**RE: Country Club Plaza Bldg 3  
Drainage Report and Conceptual Grading and Drainage Plan  
Engineers Stamp Date: 12/8/17  
Hydrology File: J13D010**

*Country Club Plaza III*  
*Drainage Management Plan*

**Re: Country Club Plaza III  
Engineers stamp date 12-8-17 (J13 / D010)**

**RE: Country Club Plaza Bldg 3**  
**Conceptual Grading and Drainage Plan**  
**Engineers Stamp Date: 6/28/17**  
**Hydrology File: J13D010**

PROJECT Country Club Pkwa III  
SUBJECT 100 YR 10 DAY CALC.  
BY DLH DATE 11.27.17  
CHECKED \_\_\_\_\_ DATE \_\_\_\_\_  
SHEET \_\_\_\_\_ OF \_\_\_\_\_

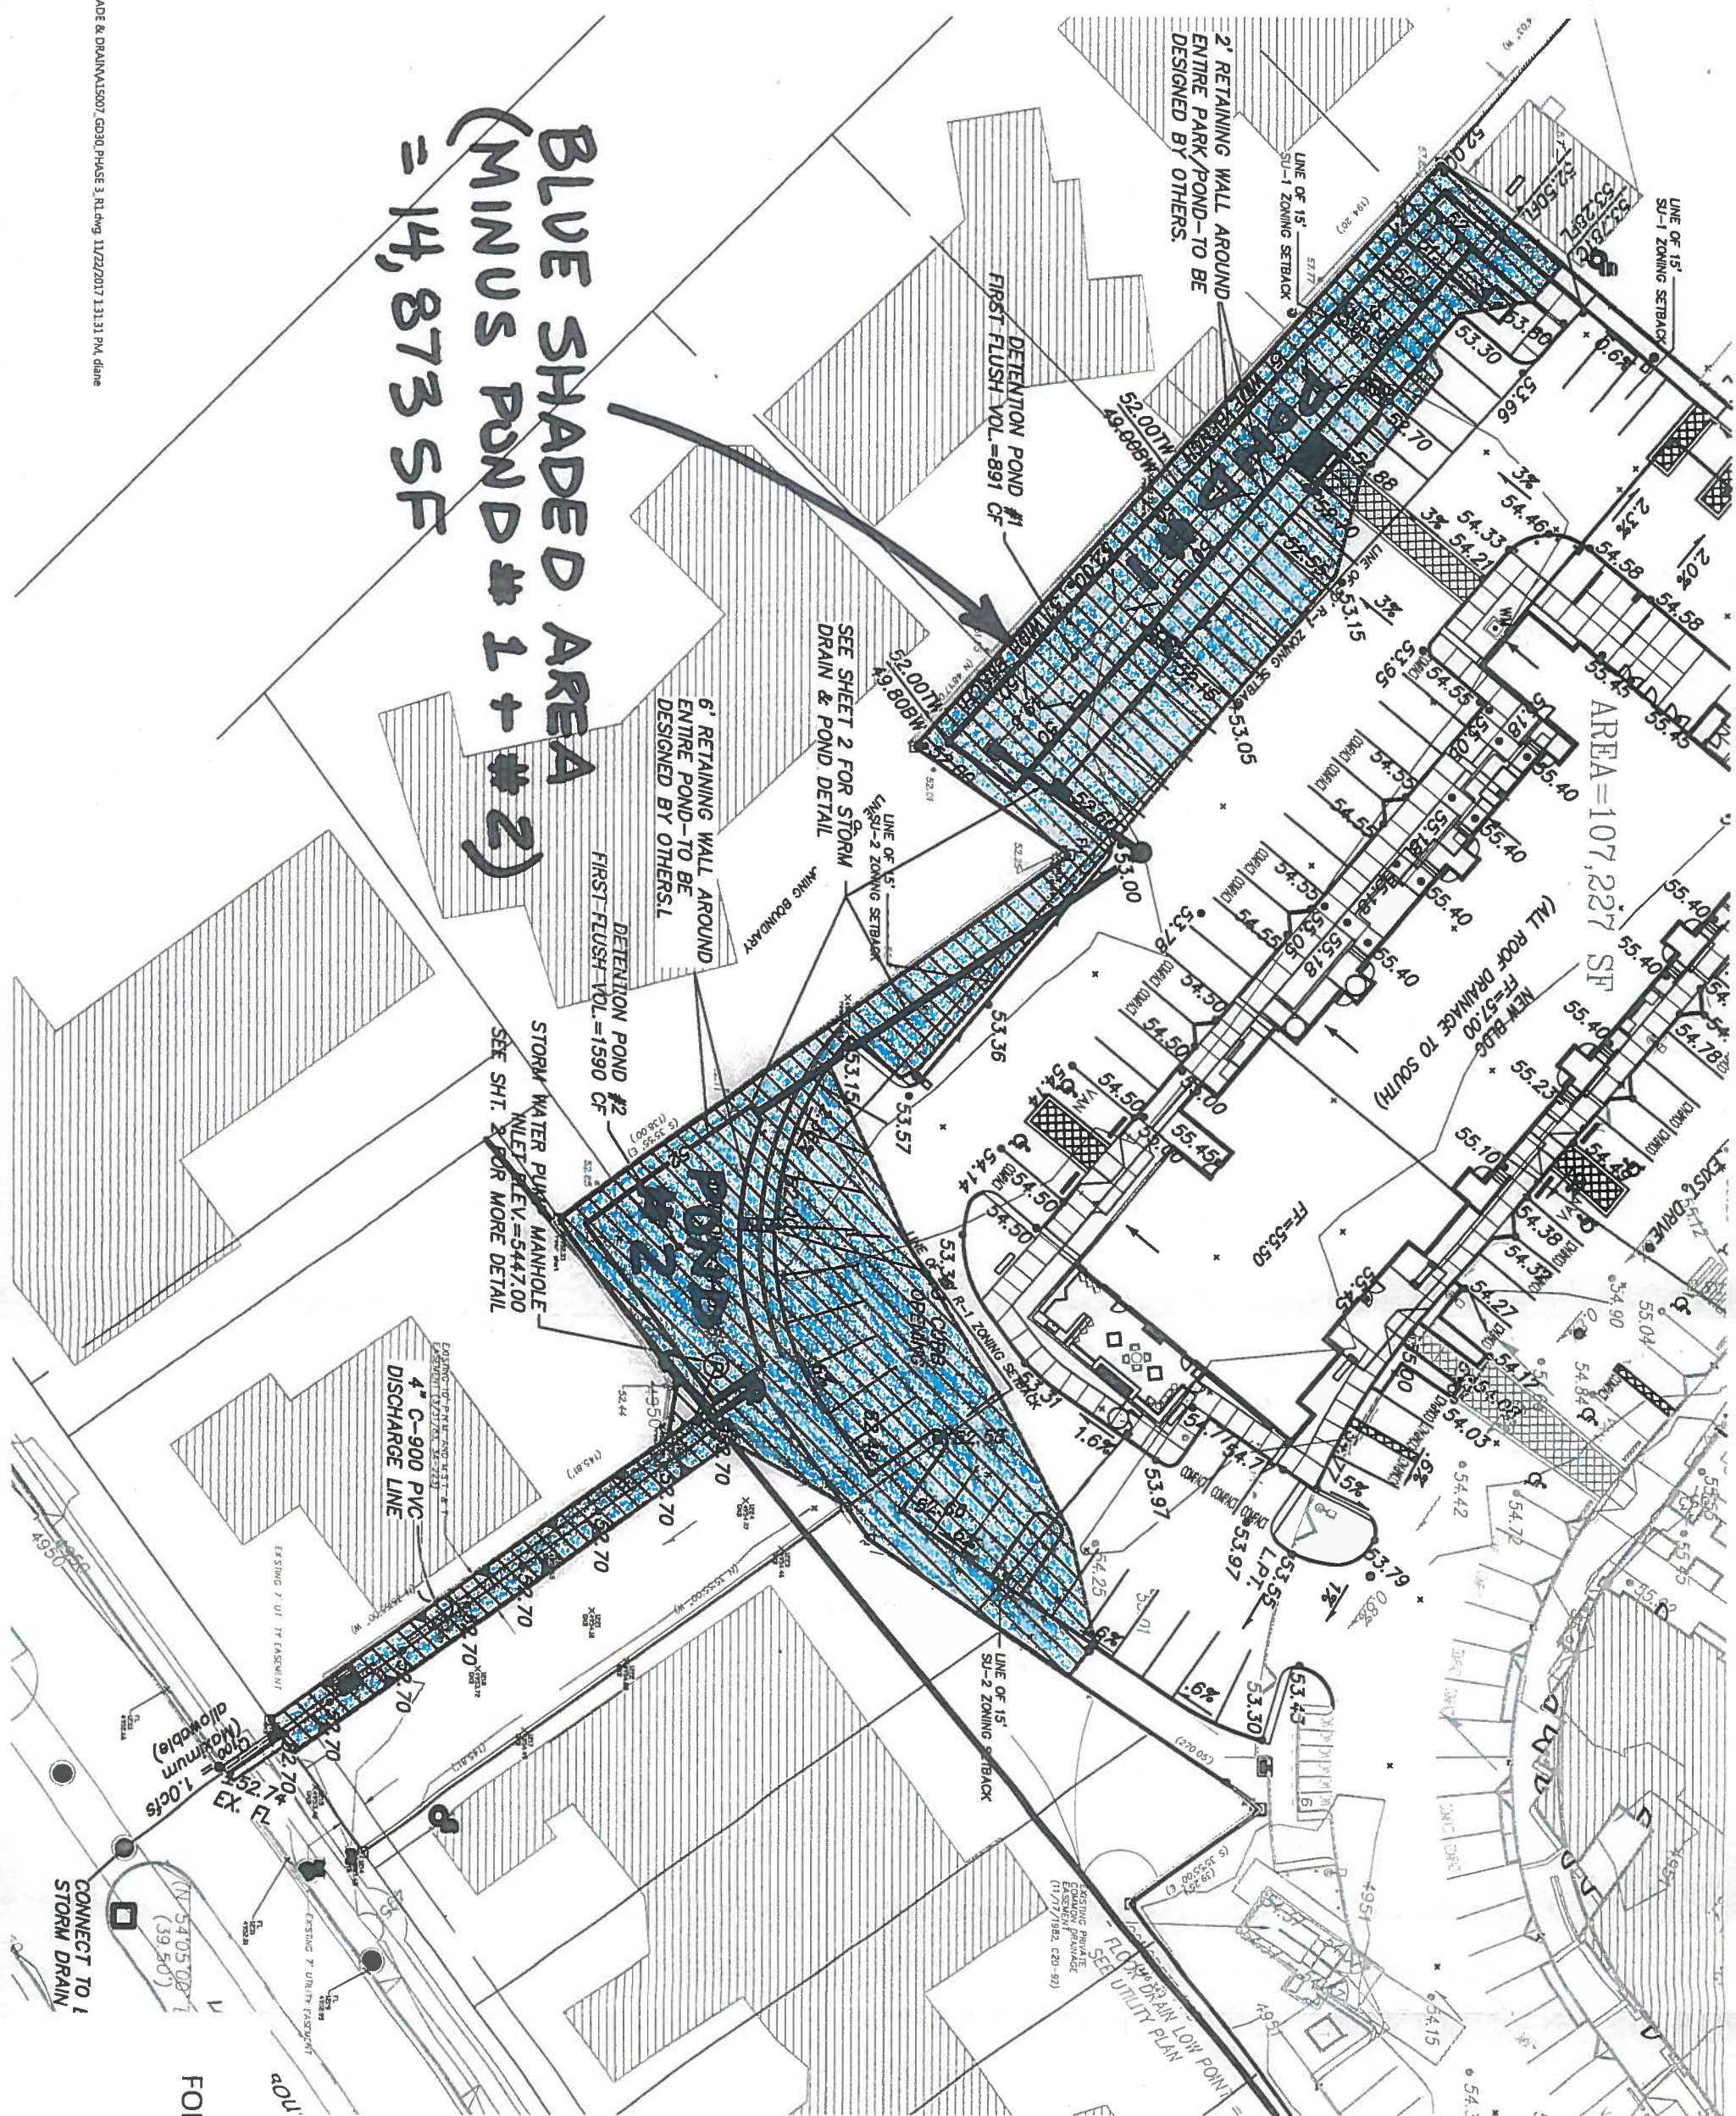
1. Demonstrate that if the pump fails, the 100-year, 10-day volume will not flood the adjacent properties. i.e.: determine this water surface elevation and show that it will either remain on the Country Club Plaza property or flow overland out to Laguna. Provide section views across the property line as required to support this.

The 100 year 10 day runoff volume has been determined and the limits of flooding in the event of a 100% pump system failure is shown on Exhibit A- Flooding limits at maximum elevation of 4953.0'. The volume calculations are provided as well.

Both pond volumes were calculated to an elevation of 4953.0' and then the limits at elevation 4953.0 were determined and then the total volume provided with this scenario were determined and compared to the actual calculated runoff volume. The volume provided is greater than the volume calculated for the 100 year 10 day storm event.

$$8358 CF + 10,944 CF + 7436.5 CF = 26,739 CF$$

PROJECT  
Country Club Plaza | Building 3  
1716 Central Avenue SW  
Albuquerque, NM 87104  
TITLE  
CONCEPTUAL GRADING & DRAINAGE PLAN

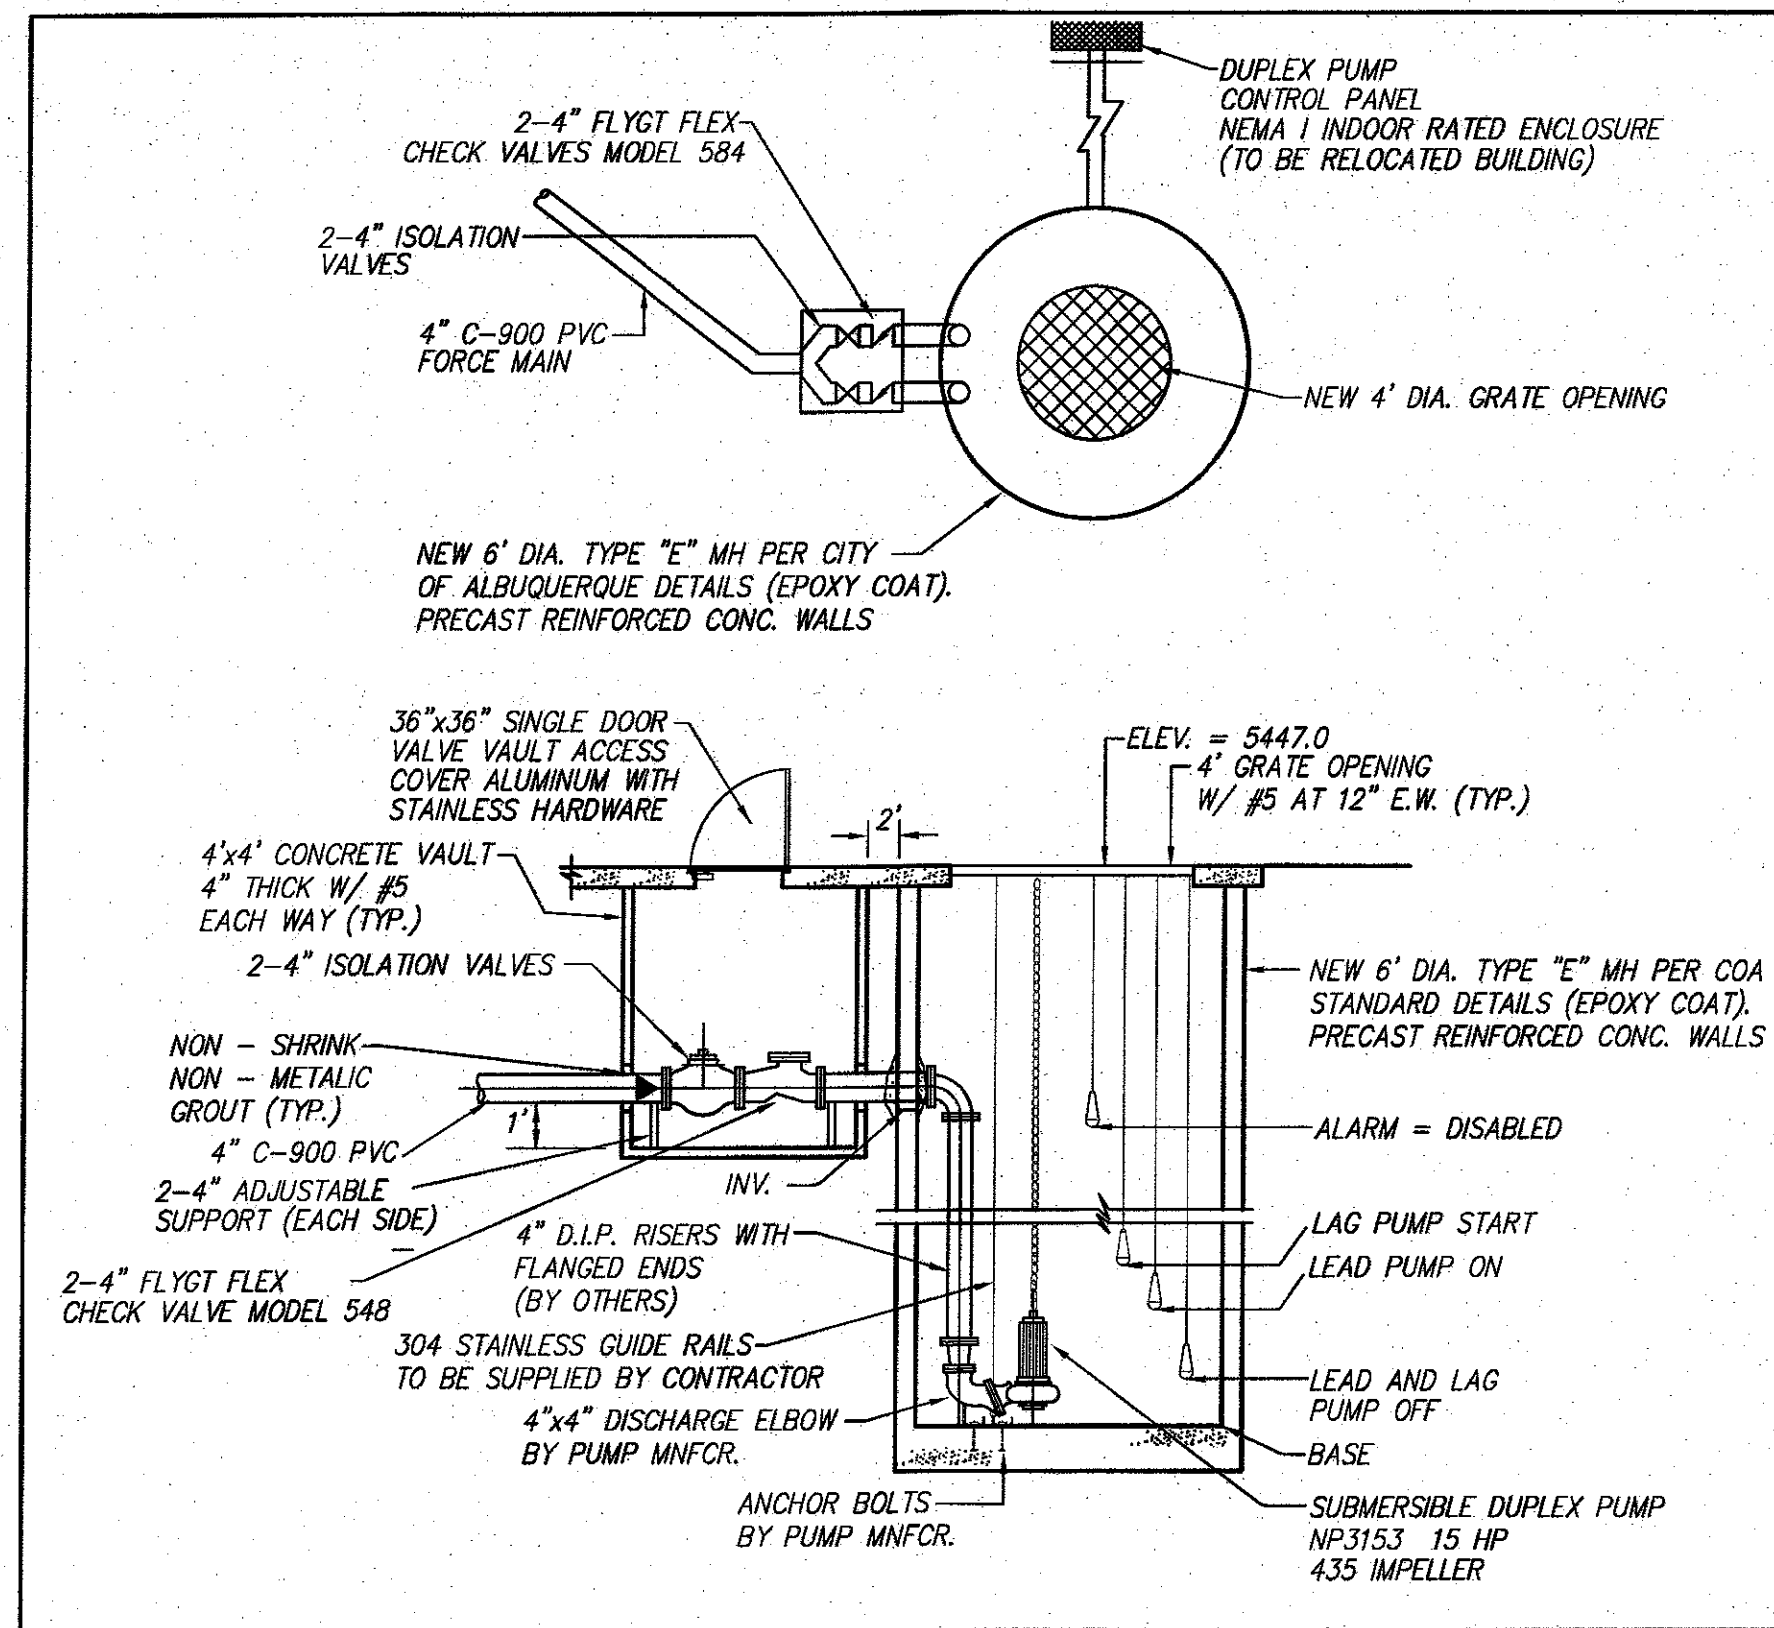
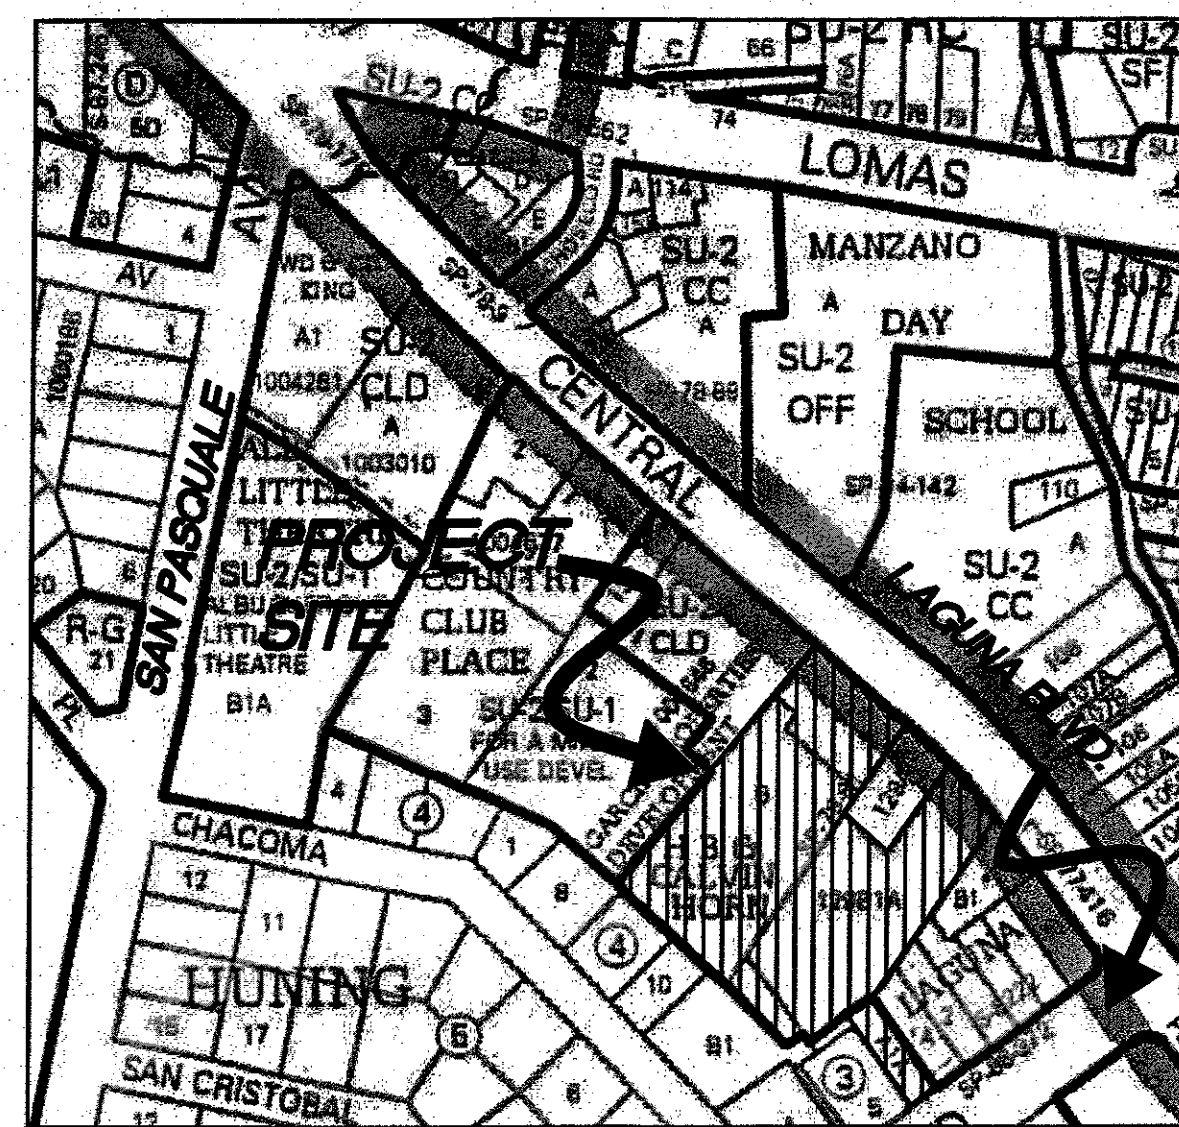
3. If the parking area is to be used for ponding, the depth may not exceed 8" in any parking stall.
4. Provide a narrative addressing the need or lack of need for an emergency spillway.

5. Add "Not for Construction" labeling to this conceptual plan; more detail will be required prior to Building Permit.
6. Maximum water surface elevation must be calculated and all buildings (including the adjoining residential properties) should be elevated 1' above the water surface elevation.

1. The 100-year 10-day storm event analysis has been added in Appendix B,
2. A short explanation about the analysis has been added to main text for 'developed conditions,
3. Text about "paring the existing wall" to elevation 4953.0 along the SW property line has been added to the G&D Plan

This plan proposes a shallow (3.6") flat swale that extends from Pond #2 to Laguna Blvd. This invert of the swale is dictated by the existing flowline in Laguna Blvd. The survey indicates this elevation to be 4952.70'. This will at least allow for runoff to be directed to Laguna in the event of a failure. This is the best that can be provided for a spillway to Laguna Blvd.

3. There is no pond storage in the parking lot.
4. Given the surrounding existing grades it is not possible to provide for any emergency overflow spillway from either of the ponds that would lead to the public right of way. The top of the ponds are at 5452.0'. Central Avenue elevations are at +/-54.0'. The flowline elevation at Laguna Blvd. is at +/- 52.74'. It looks like the best that can be provided would be a 0% slope V-ditch leading from Pond #2 to Laguna Blvd. with an invert of 52.74 to match the flowline in Laguna Blvd.

5. This note has been added to both Conceptual Grading plan sheets,
6. All buildings are at least 1.0' above the maximum water surface elevation.
7. Okay.
